PRODUCT CHANGE | 45MM LI-ION 6NM MOTOR

DISCONTINUED PRODUCT	REPLACEMENT PRODUCT	CHANGES MADE	
			YES	NO
DESCRIPTION.	AUTOMATE Li-ion [45mm/3.0Nm/28r] ARC-MTR012V 5V LI-ION Q3.0NM MOTOR [Ø45/5V/20RPM]	AUTOMATE LI-ION 6NM MOTOR [Ø45/5V/24RPM]	<input checked="" type="checkbox"/>	<input type="checkbox"/>
CODE.	MTDCBRFQ45-3 & MT01-1345-069001	MT01-1345-069003	<input checked="" type="checkbox"/>	<input type="checkbox"/>
PACK SIZE.	1 10 UOM	1 10 UOM	<input checked="" type="checkbox"/>	<input type="checkbox"/>
PRICE.	N/A	N/A	<input type="checkbox"/>	<input checked="" type="checkbox"/>
COLOUR / FINISH.	White	White - 069	<input type="checkbox"/>	<input checked="" type="checkbox"/>
LENGTH.	32 3/16" 817mm		<input type="checkbox"/>	<input checked="" type="checkbox"/>
IMAGE.			<input type="checkbox"/>	<input checked="" type="checkbox"/>
USE WITH.	All ARC Controls		<input type="checkbox"/>	<input checked="" type="checkbox"/>
TRANSITIONING.	July 2025

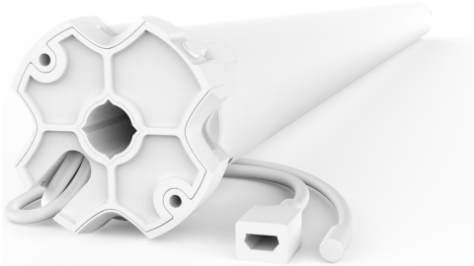
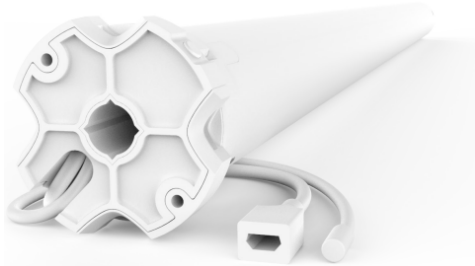
- Quiet motor Range Operation
- Increases Torque
- Increase Default Speed to 24rpm
